**SECTION 87F REPORT OF PETER FREDERICK KINLEY –
HYDROLOGY AND FLOODING**

**MANAWATŪ-WHANGANUI REGIONAL COUNCIL AND GREATER
WELLINGTON REGIONAL COUNCIL**

28 April 2023

Figure 1: Example of reported increases in flooding outside the designation boundary

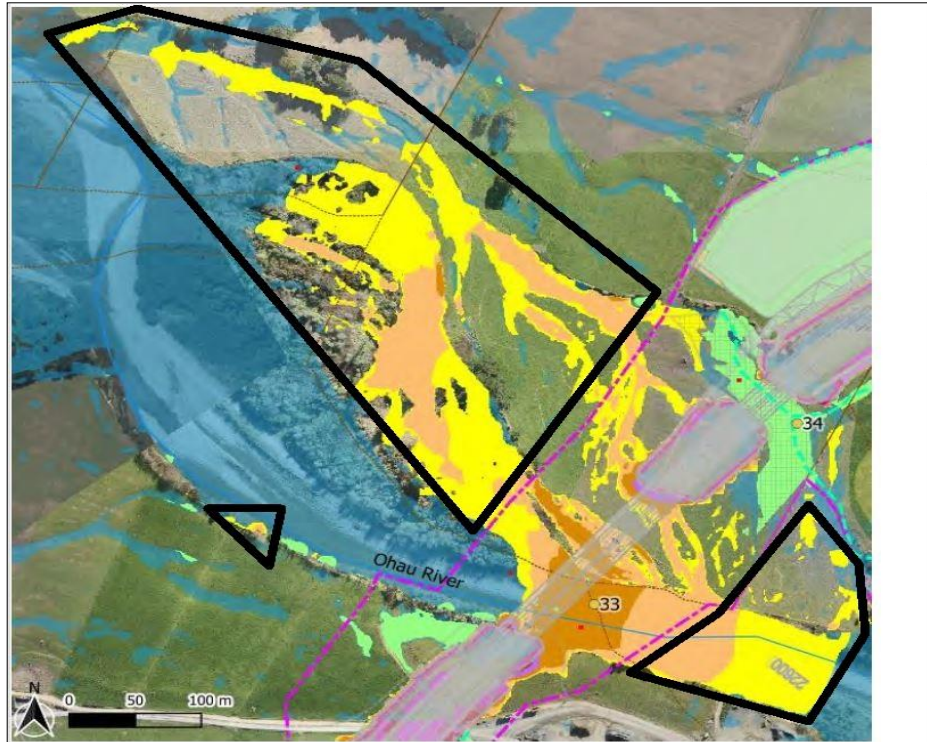
30. The assessment of effects shows the 10% AEP flood event will cause increases in water levels outside the designation at a level that I consider to be significant. For example, Figure F.14 of Technical Assessment F shows that increases in peak water levels in the 10% AEP flood event of at least 50mm occur approximately 500m downstream of the designation boundary, and increases of more than 200mm occur approximately 200m downstream of the designation boundary. I have reproduced Figure F.14 of Technical Assessment F below and marked the three areas where flood increases are shown to occur outside the designation boundary with thick black lines.

31. I compared the information provided in Figure F.14 of Technical Assessment F to the information in Figure F.13, which is for the same location and the 1% AEP +CC flood event. Figure F.13 shows that while increases in water level still occur downstream of the designation boundary, their extent is greater in the smaller 10% AEP flood event than in the 1% AEP +CC flood event. On this basis I disagree with Waka Kotahi's assertion at paragraph 36 of Technical Assessment F that *"The effects of the Ō2NL Project on smaller and more frequent events than 1:10 AEP will be much less than the above events..."*.

Figure 2: Increases in flooding outside the designation boundary shown in Waka Kotahi's Technical Assessment F Figure F.13

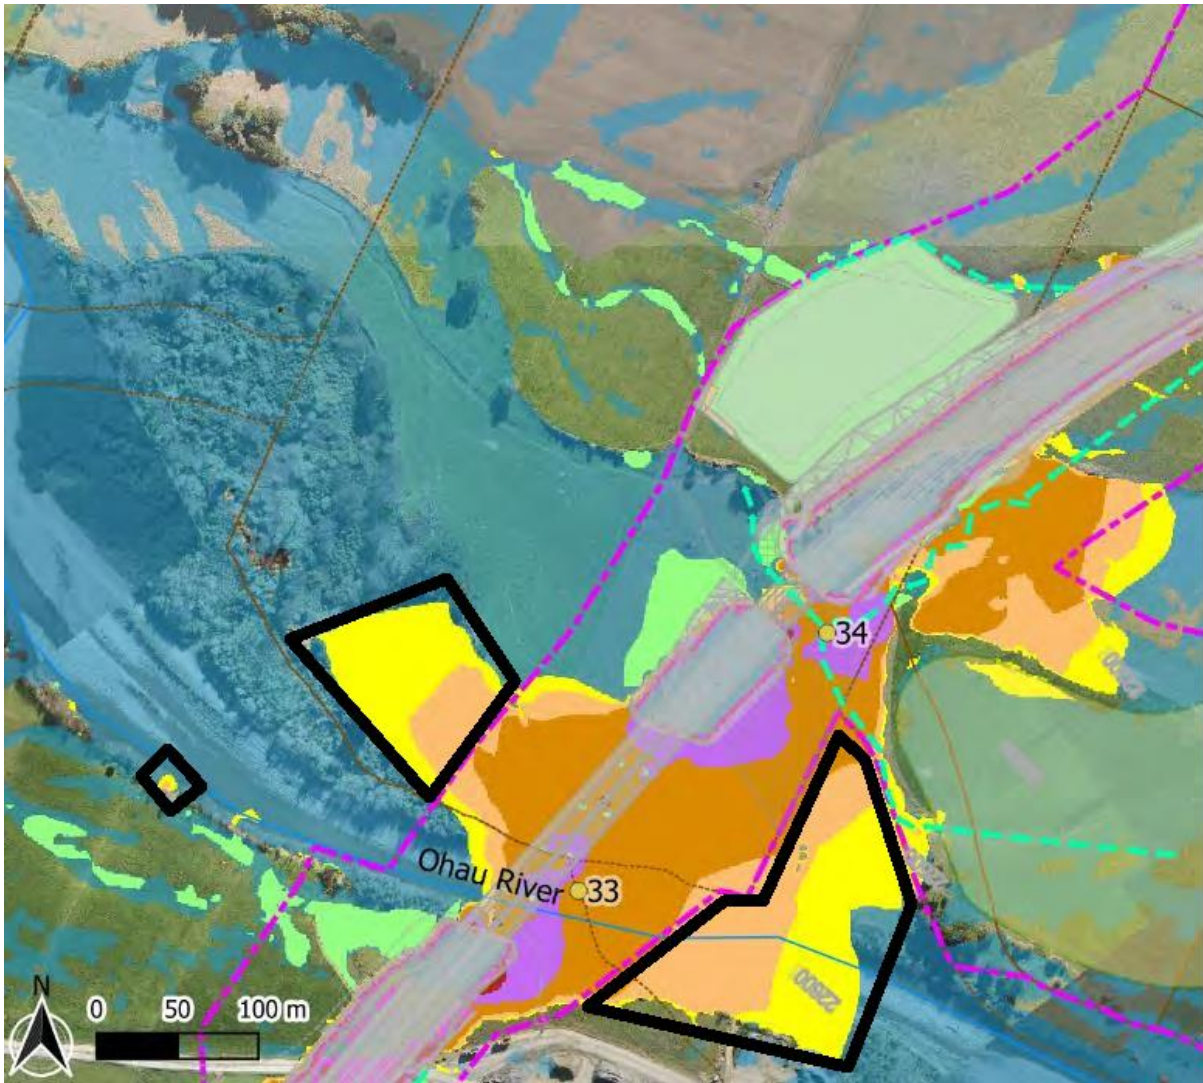
- (a) Figure F.13 shows an increase in flood levels of 0.05m to 0.1m more than 100m downstream of the Ōhau River bridge, which is more than Waka Kotahi's proposed threshold of <0.05m downstream 100m beyond the proposed designation.

Figure 3: Increases in flooding outside the designation boundary shown in Waka Kotahi's Technical Assessment F Figure F.14

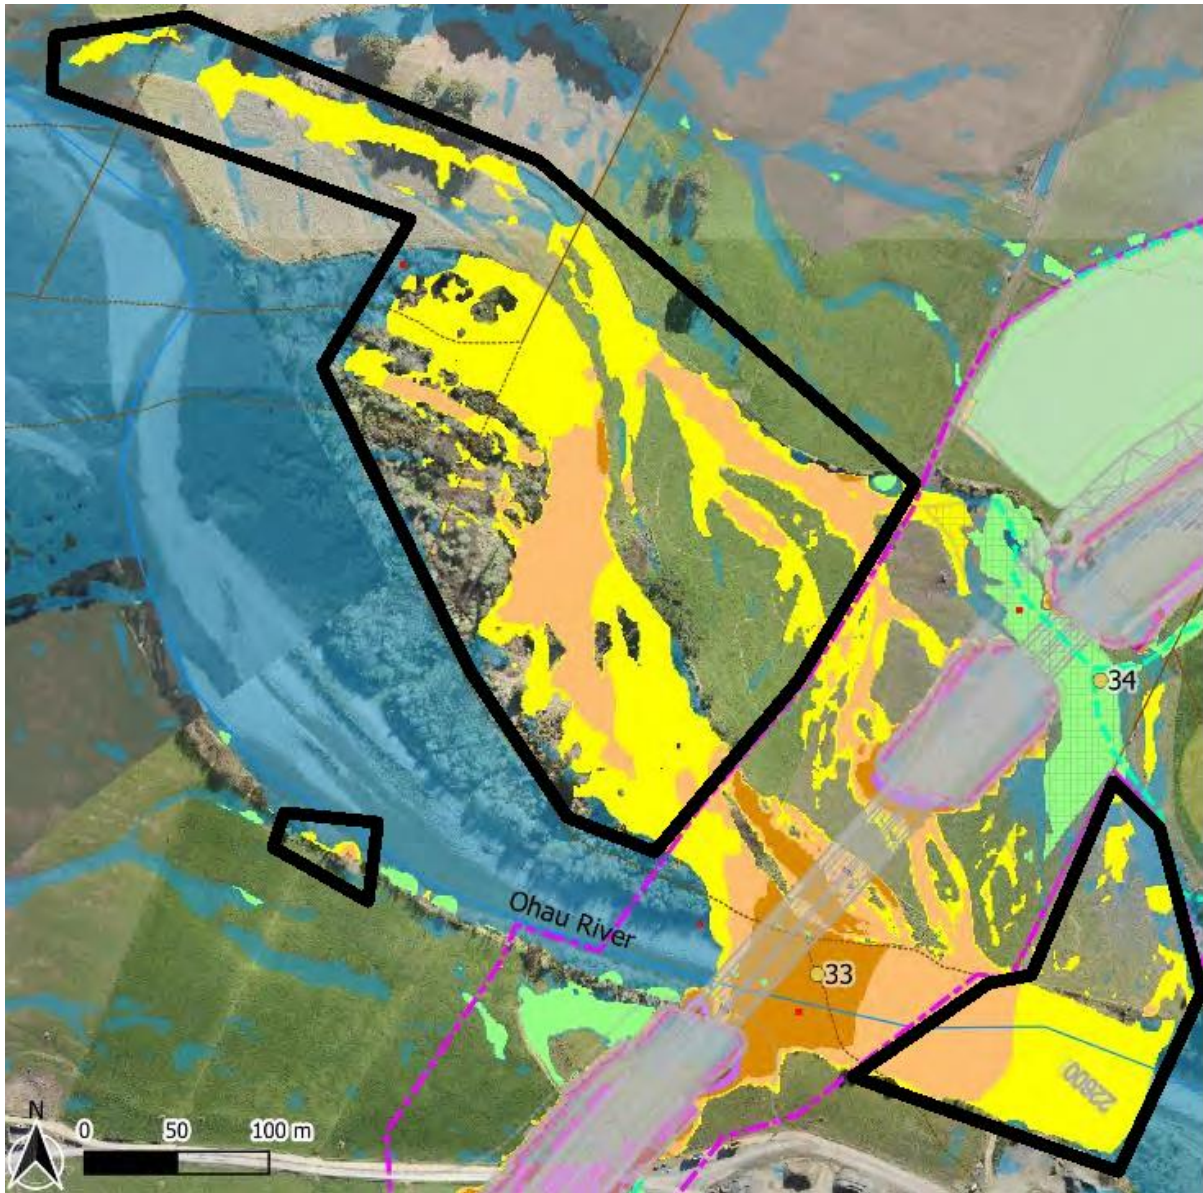
- (b) Figure F.14 shows an increase in flood levels of 0.2m to 0.5m and significant areas where the increase is 0.1m to 0.2m or 0.05m to 0.1m up to several hundred metres downstream of the Ōhau River bridge, which is more than Waka Kotahi's proposed threshold of <0.05m downstream 100m beyond the proposed designation.

Figure 4: Increases in flooding outside the designation boundary shown in Waka Kotahi's Technical Assessment F Figure F.19

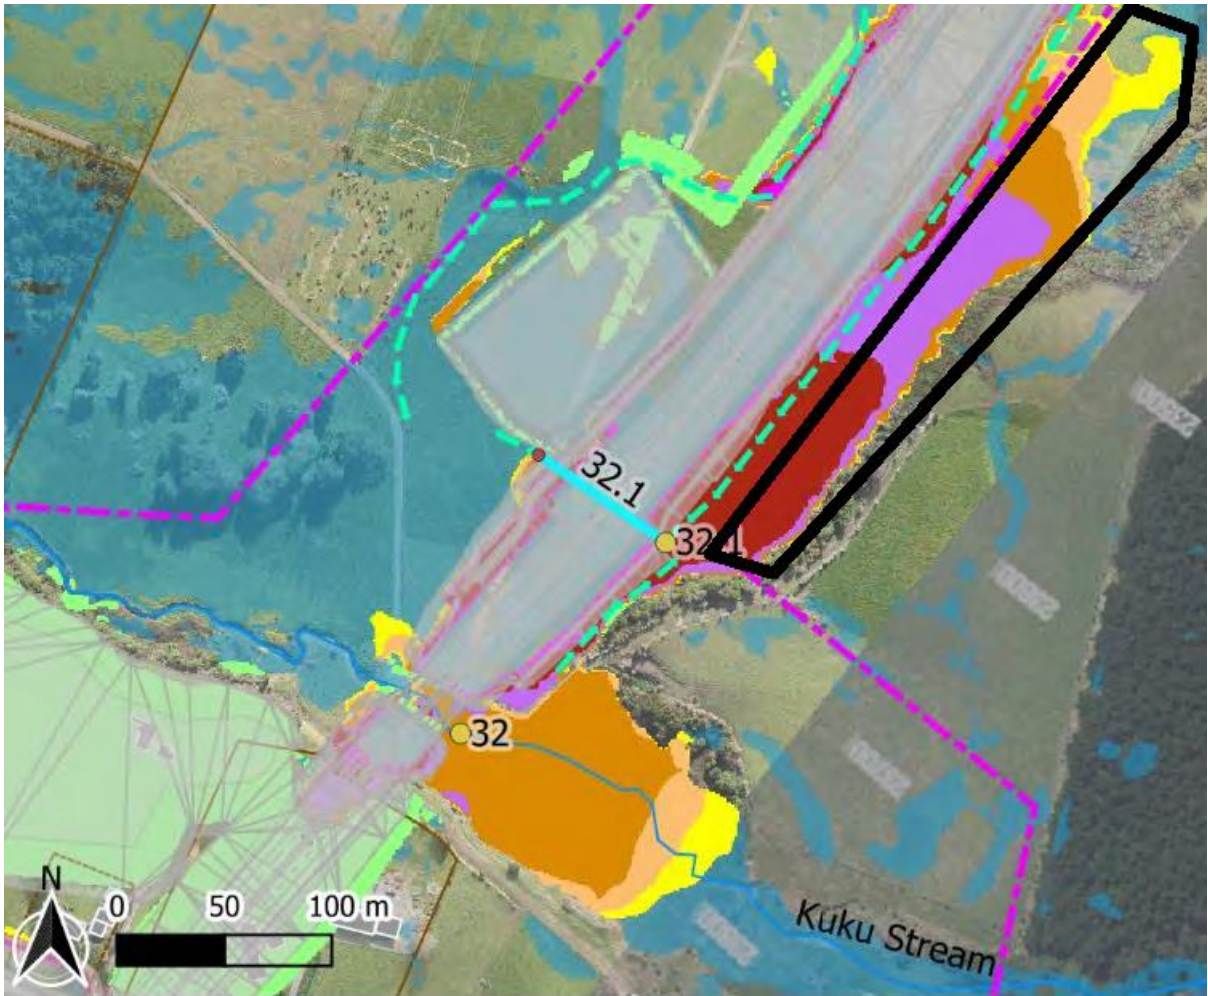
- (c) Figure F.19 shows increases in flood levels of up to 1 to 1.5m at the designation boundary on the upstream side in the 1% AEP + CC flood event, which is more than Waka Kotahi's proposed threshold of <0.5m at the designation boundary.

Figure 5: Increases in flooding outside the designation boundary shown in Waka Kotahi's Technical Assessment F Figure F.23

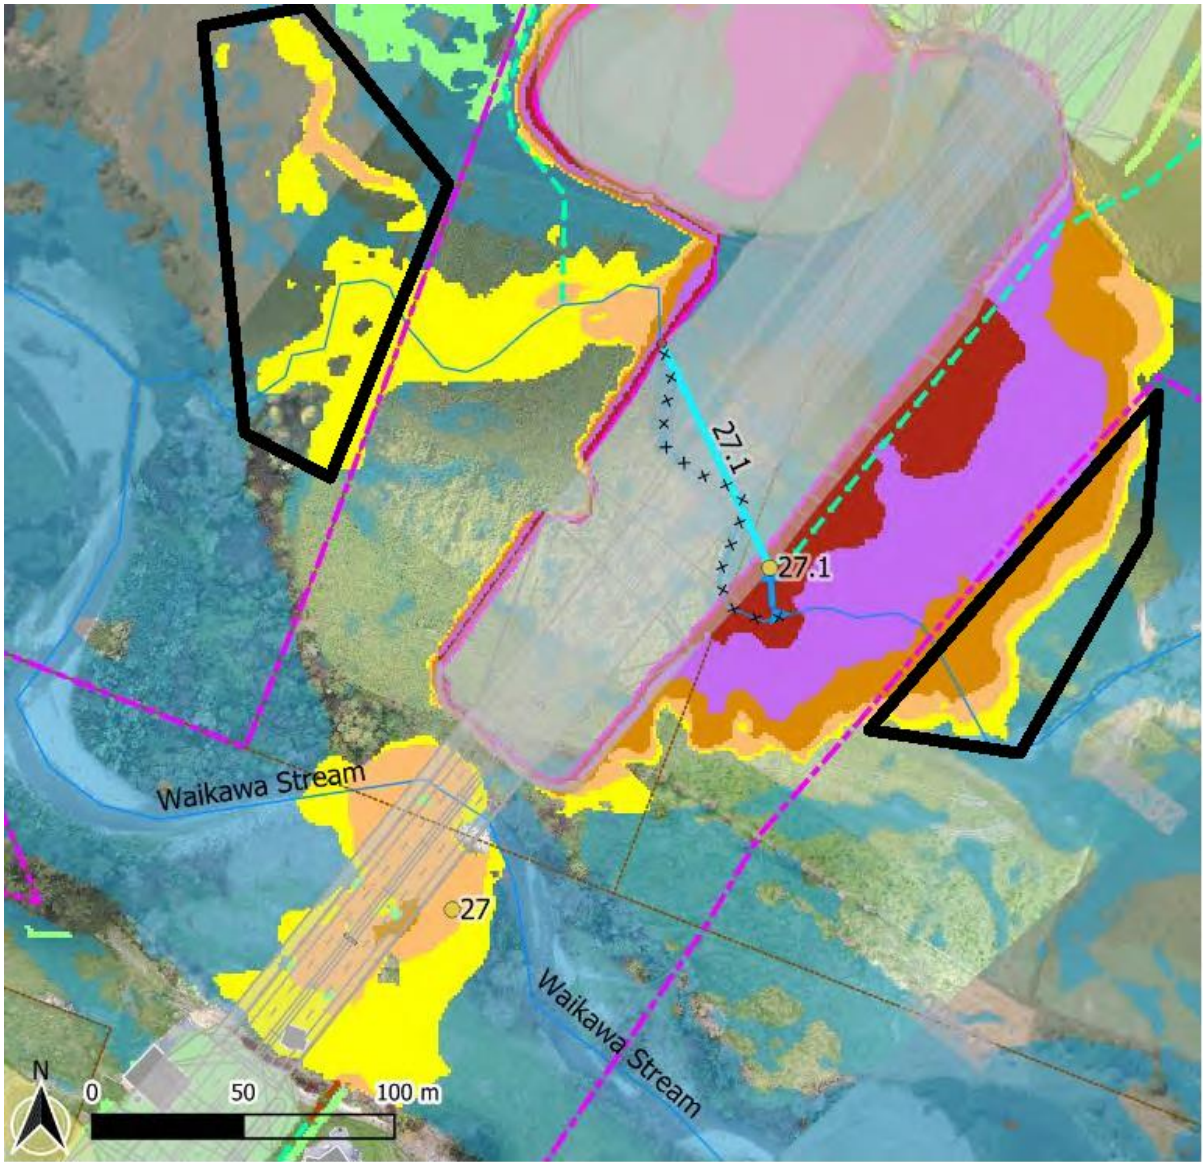
- (d) Figure F.23 shows an increase in flood levels of 0.1m to 0.2m downstream of the designation boundary, which may not meet Waka Kotahi's proposed threshold of <0.2m downstream at the proposed designation boundary.

- (e) Figure F.23 also shows an increase in flood levels of 0.5m to 1m at the designation boundary on the upstream side in the 1% AEP + CC flood event, which is more than Waka Kotahi's proposed threshold of <0.5m at the designation boundary.

Figure 6: Increases in flooding outside the designation boundary shown in Waka Kotahi's Technical Assessment F Figure F.24

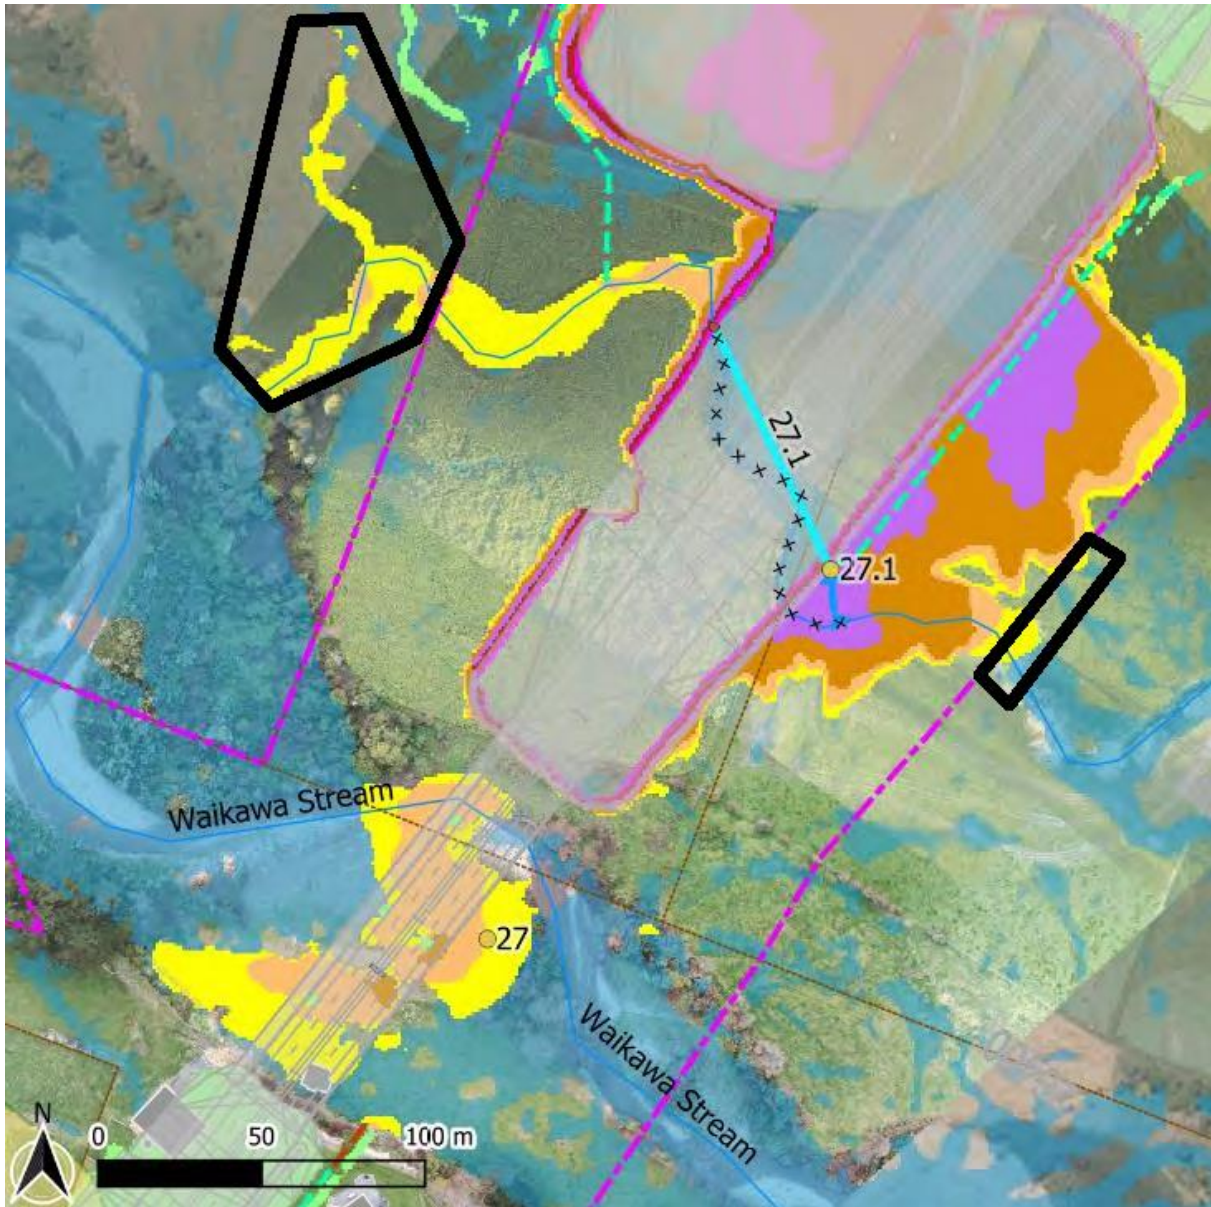
- (f) Figure F.24 shows a possible area where an increase in flood levels of 0.1m to 0.2m occurs in the 10% AEP flood event, which may not meet Waka Kotahi's proposed threshold of <0.2m at the upstream designation boundary.

Figure 7: Increases in flooding outside the designation boundary shown in Waka Kotahi's Technical Assessment F Figure F.31

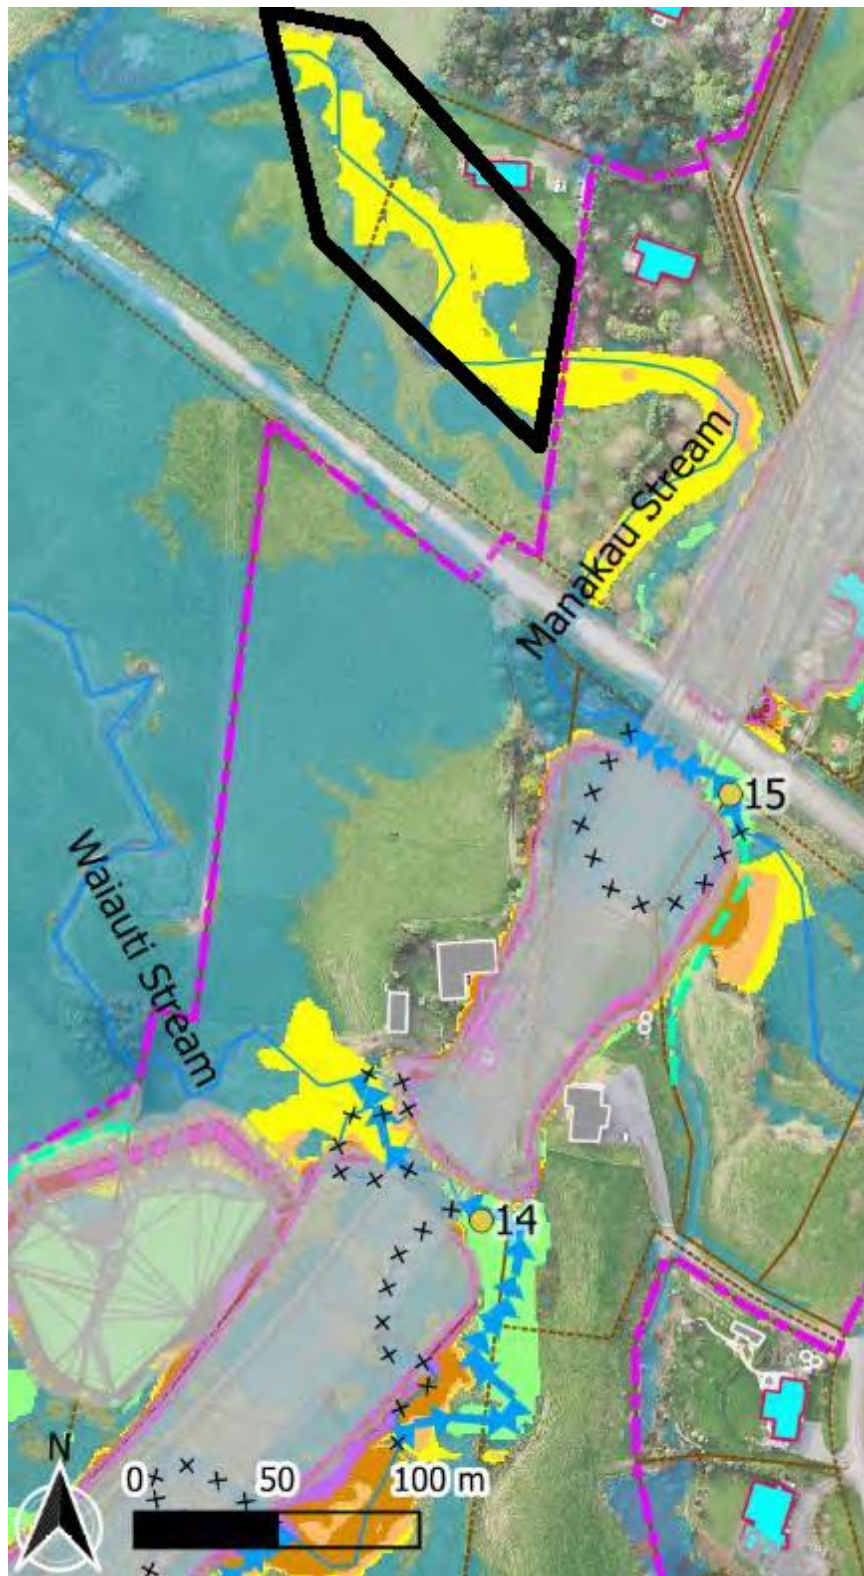
- (g) Figure F.31 shows an extensive area with increased flood levels of 0.05m to 0.1m more than 100m downstream of the proposed designation boundary in the 10% AEP flood event in the Manakau Stream, which is more than Waka Kotahi's proposed threshold of <0.05m at downstream 100m beyond the designation boundary.
